RECEIPT DATE: 9/24/18 **ONSITE SEWAGE DISPOSAL SYSTEM** P 564012

PROPERTY ADDRESS: 12348 Point Ridge Drive

DATE <u>5/17/18</u>	PROJECT No. <u>2171</u>
ATTENTION	
RE: <u>REGAN PROPERTY LOT 5</u>	
<u>ONSITE SEWAGE DISPOSAL</u>	
<u>SYSTEM DESIGN PLAN</u>

TITLE: **ONSITE SEWAGE DISPOSAL SYSTEM DESIGN PLAN**

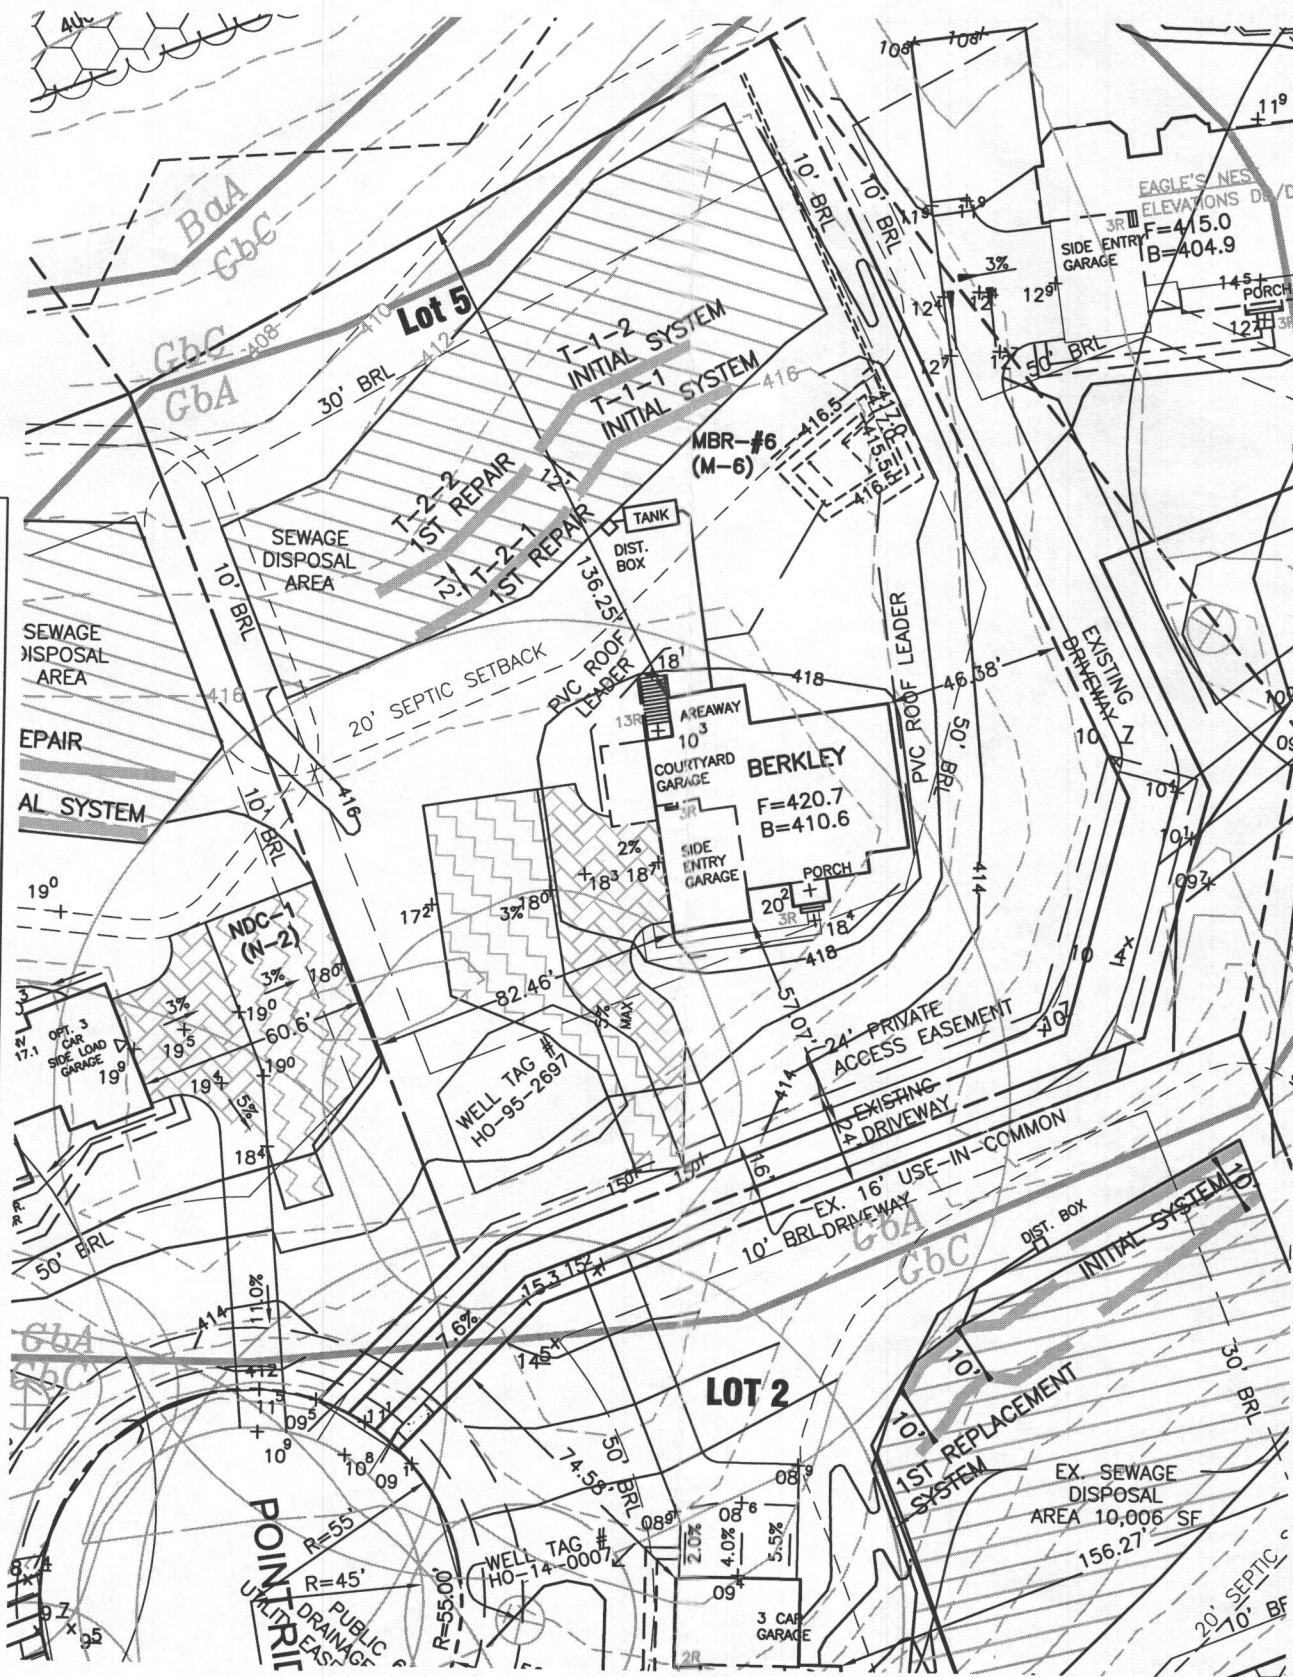
John , I have a few revisions needed for this lot on the OSDS plan.

1. Please separate the initial system and the first repair into 2 trenches on contour. As shown in the diagram below:

This design will give the best utilization for the area and allow more room for future systems.

TITLE: **ONSITE SEWAGE DISPOSAL SYSTEM DESIGN PLAN**

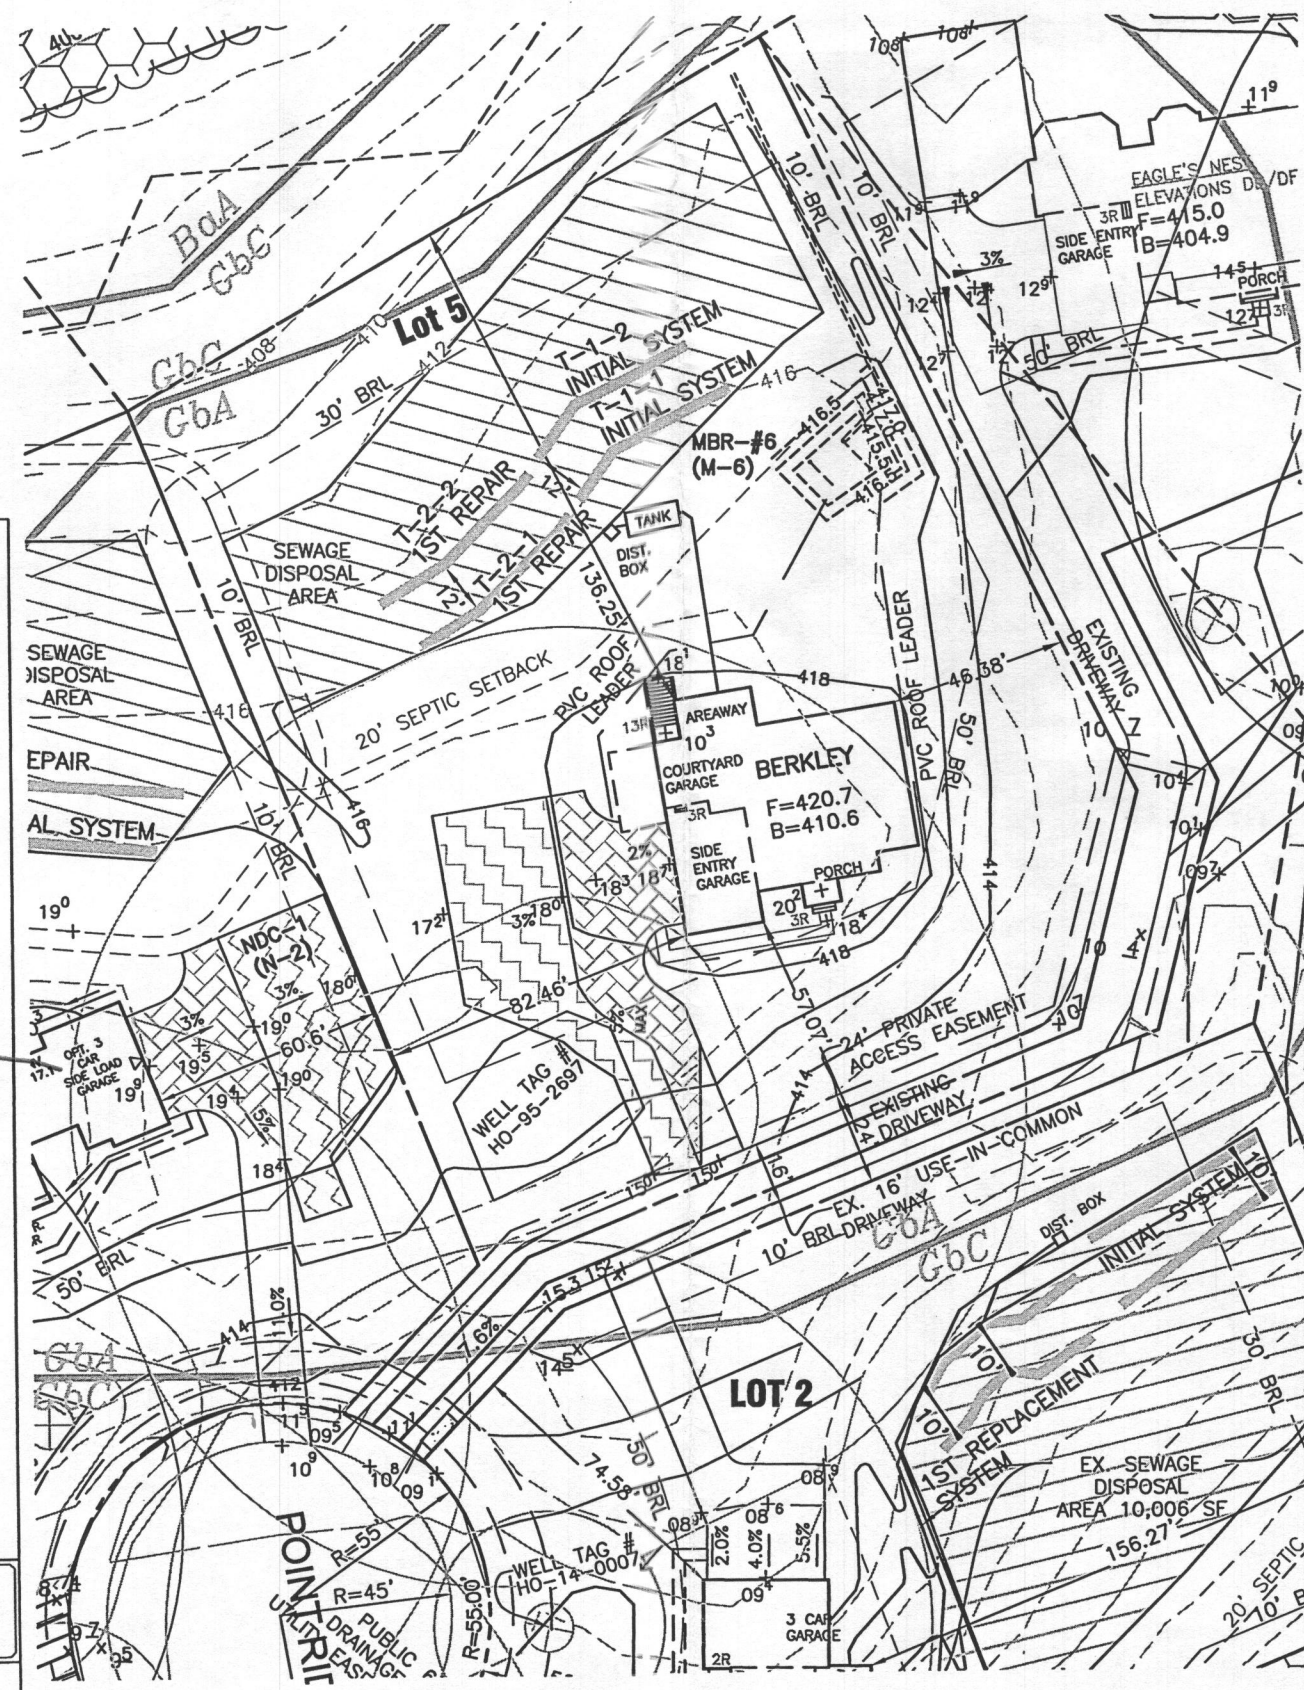
I have approved the OSDS plan for lot #5. However, the well line will have to be sleeved under the driveway during installation .
